BUILDING COMPLETION REPORT.

AMMENDED PLAN OF PROPOSED BUILDING ON

PLOT NO 71 SHEET NO JL 6

JAIL QUARTER

PLAN FOR PROPOSED BUILDING ON PLOT N^o

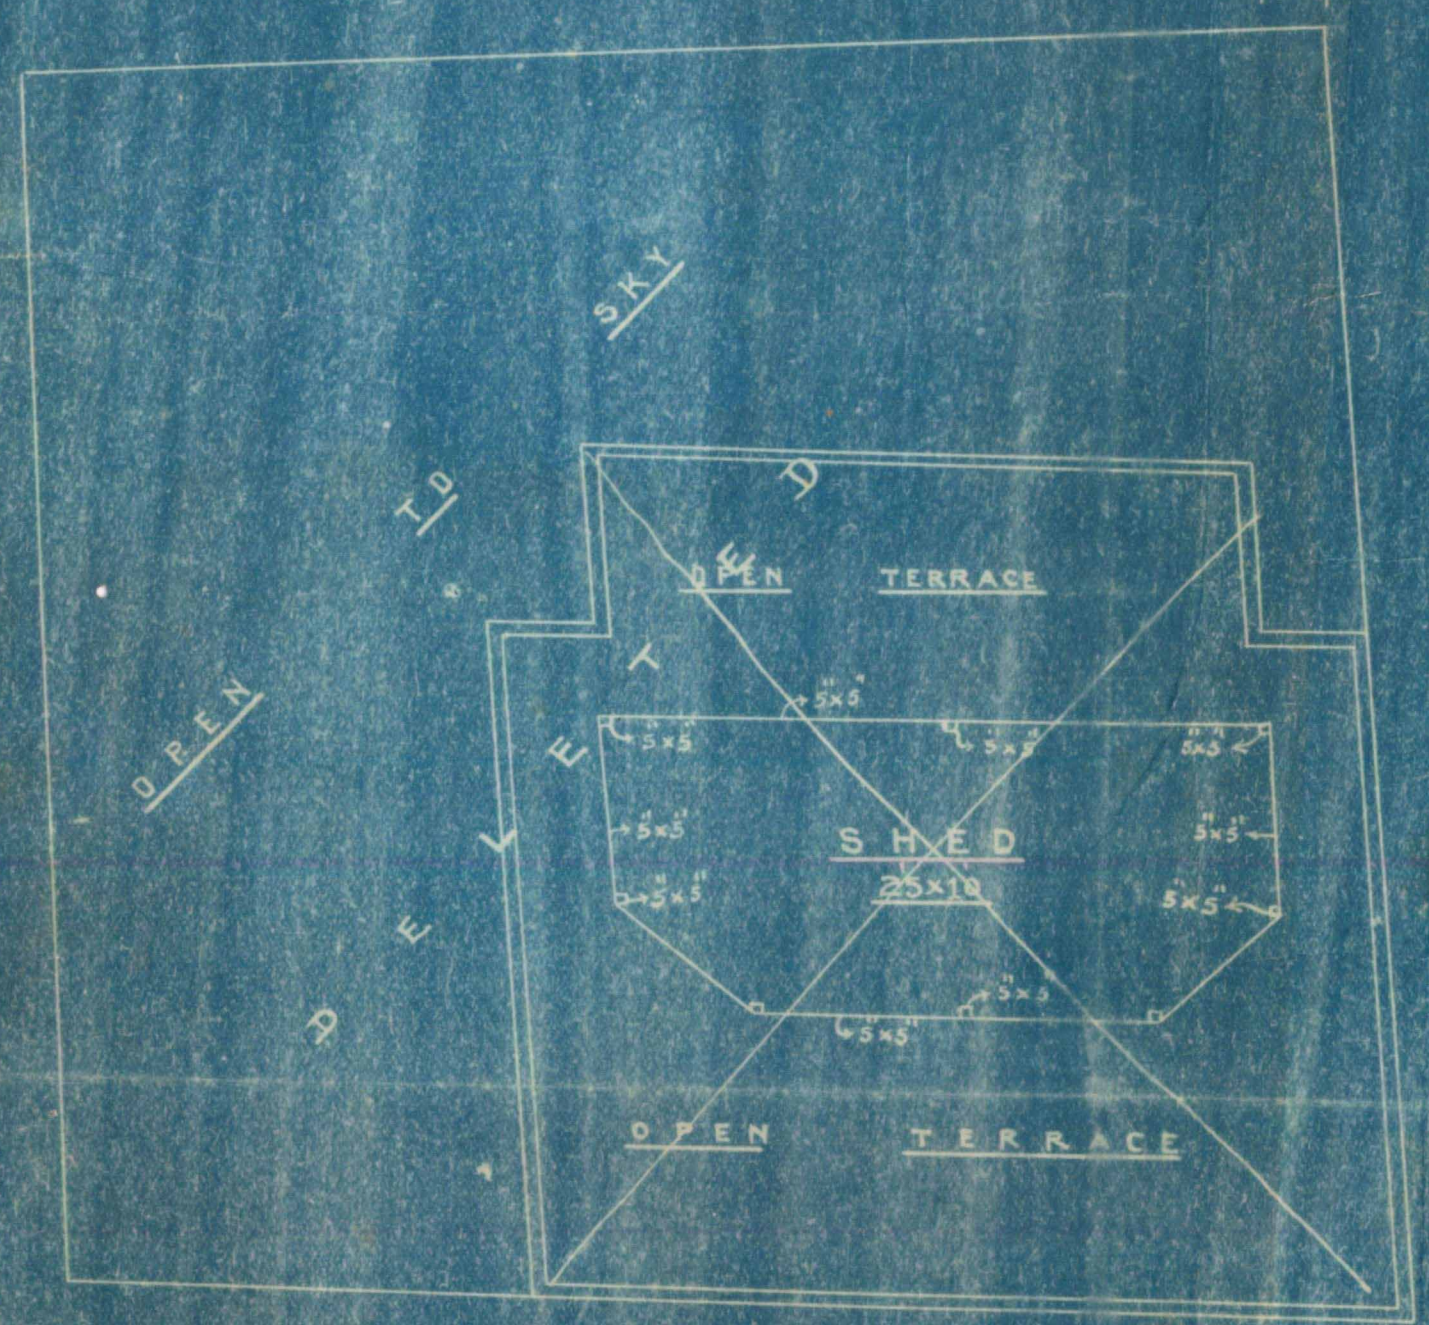
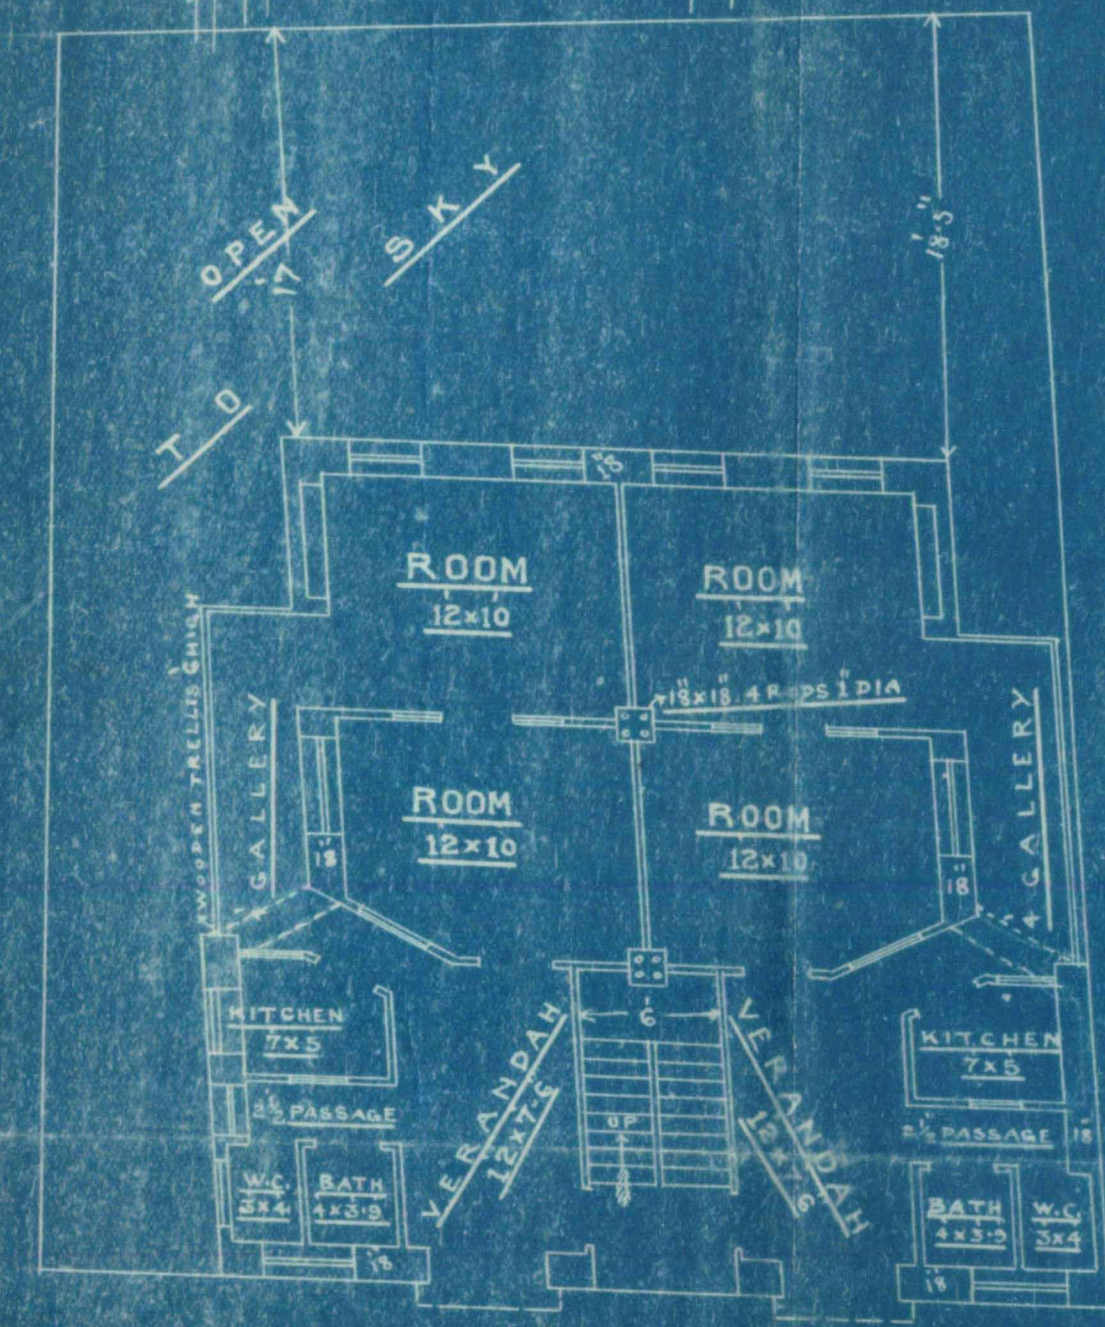
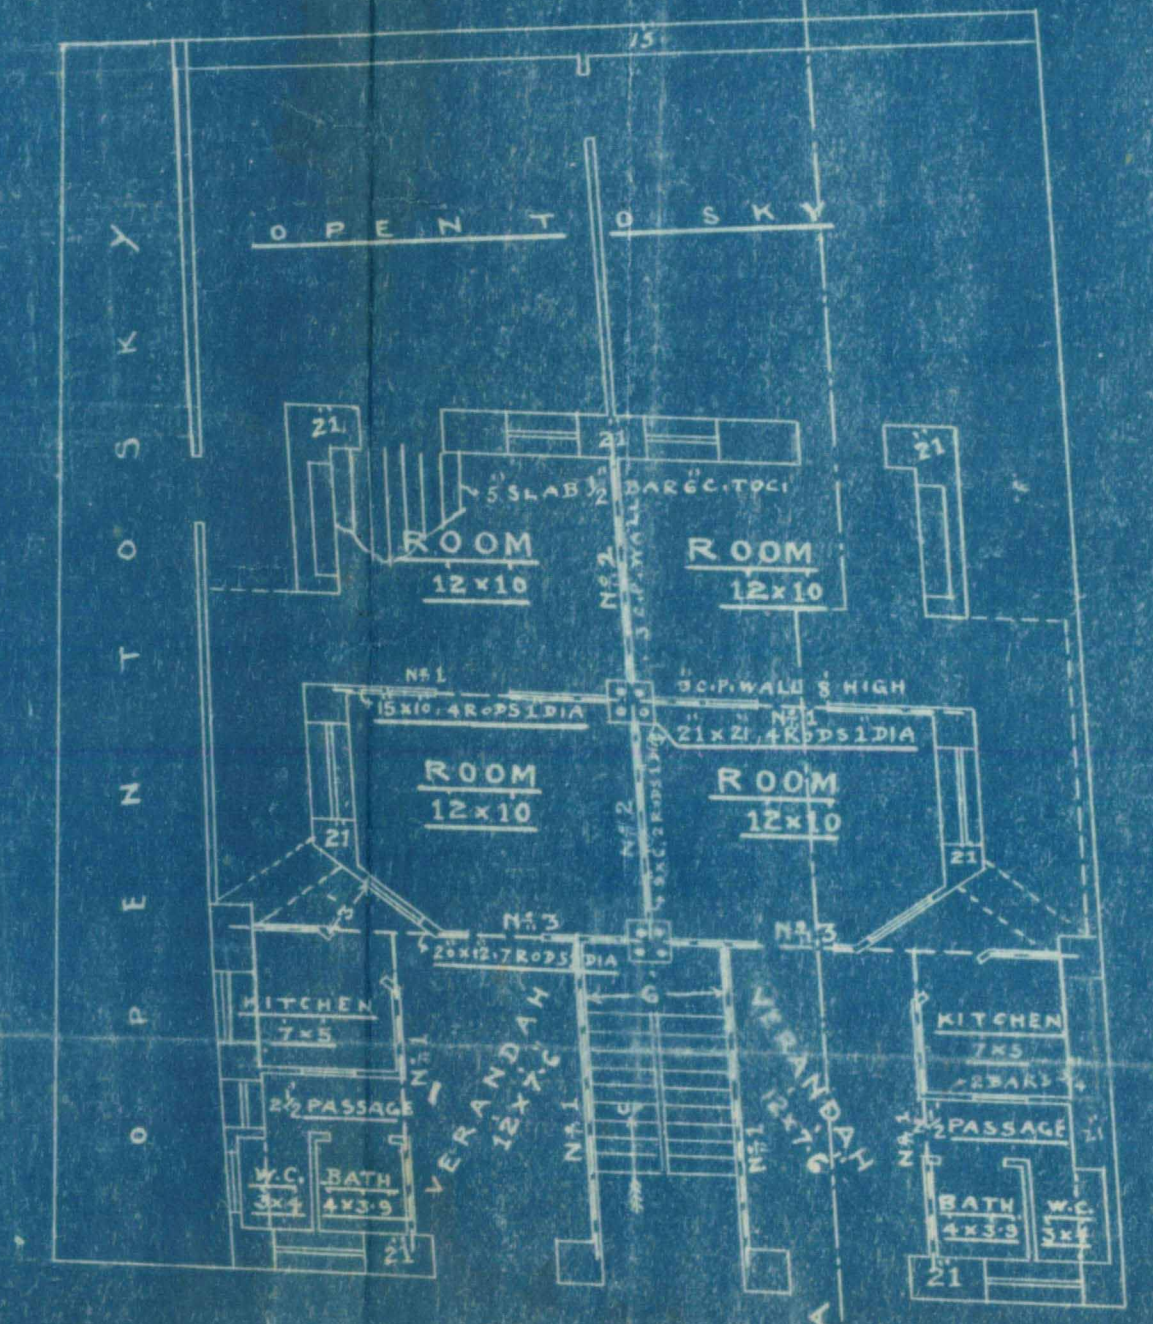
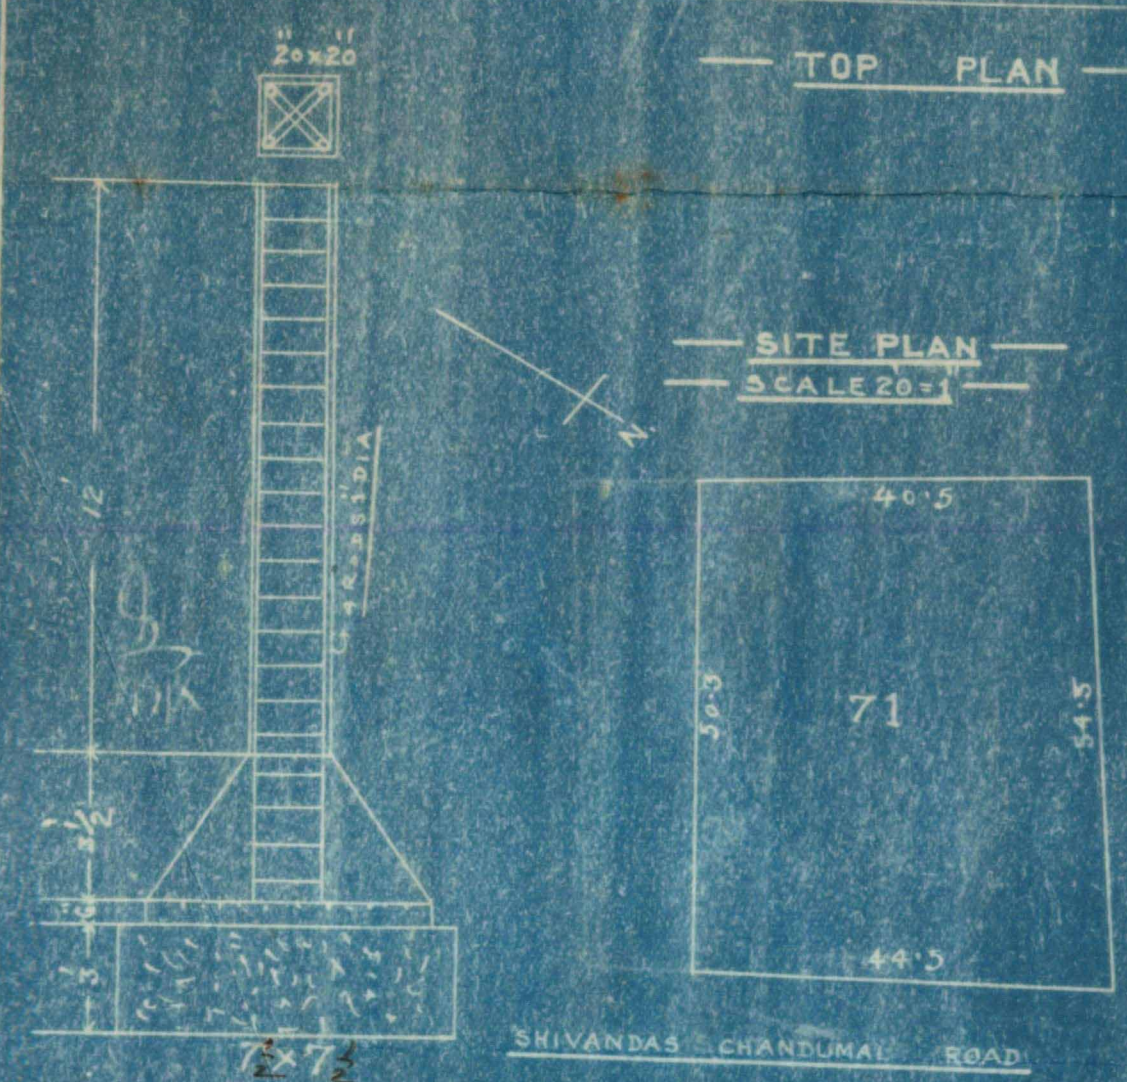
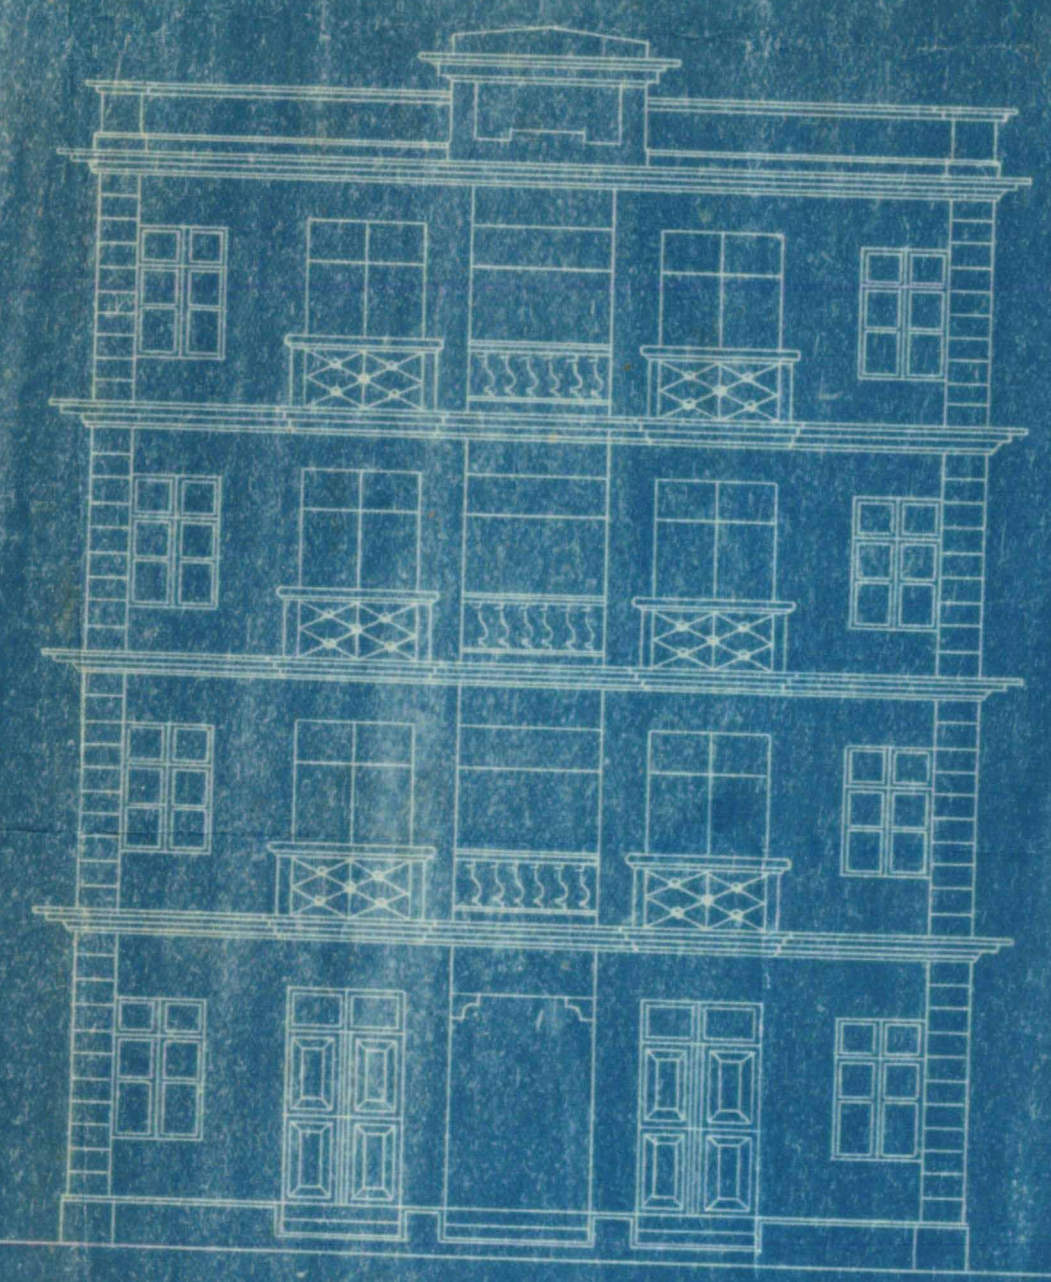
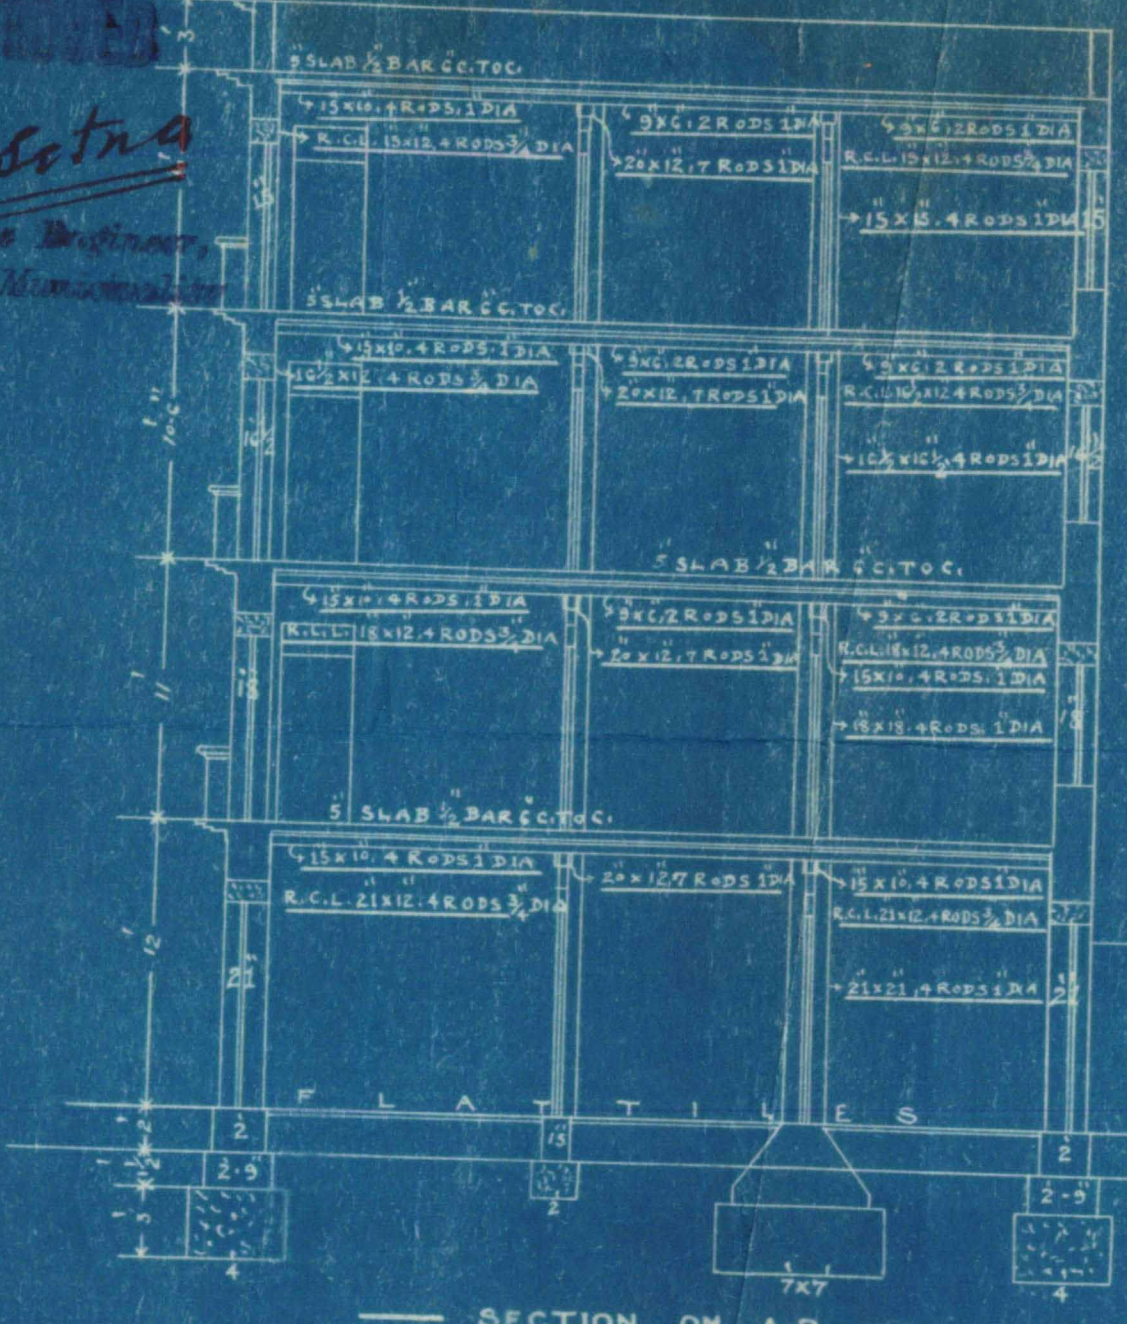
(1) The external walls to be 2 feet thick(2) The R.C. pillars to be continued right up to the same houseRequirements Complied withNo. Objection6/2
2/23Date 28.2.29
Mr. C. B.
Building Surveyor.
